Preliminary & Final Drainage Report

Engineering Review

EPC Planning & Community
Development Department

Sanctuary of Peace Residential Community

PROPOSED DRAINAGE MAP (DETAIL)

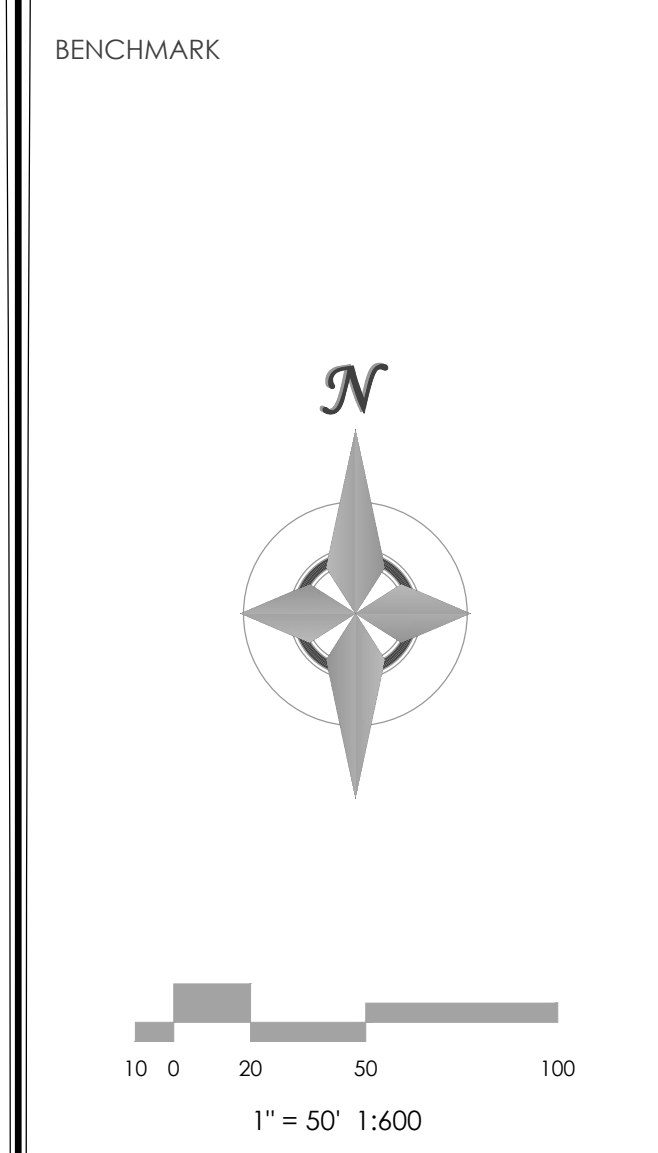
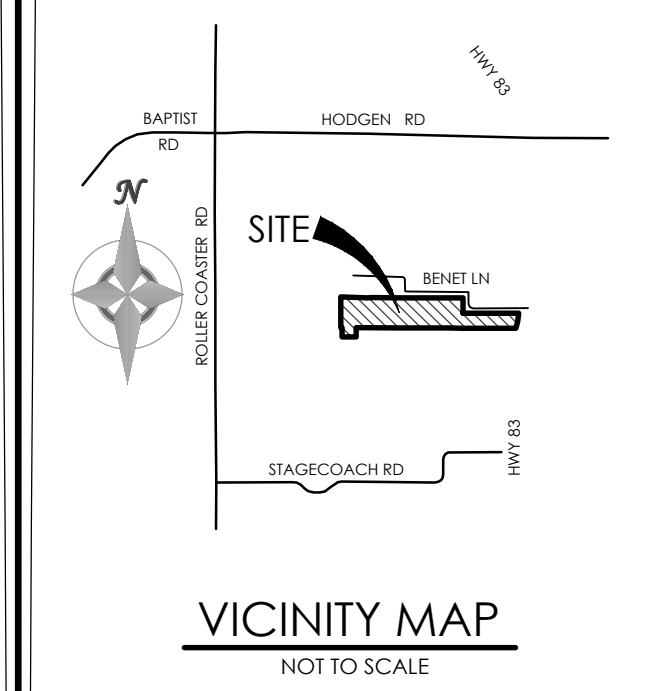
Show the final grades for the buildings.
Show the elevations on the contours. Both
existing and proposed.

Show the proposed culvert to get this building to
drain to the Smith Creek FSSF.

Show these unique roof drain systems on the site development plan SDP.

Show these unique roof drain systems on the site development plan SDP.
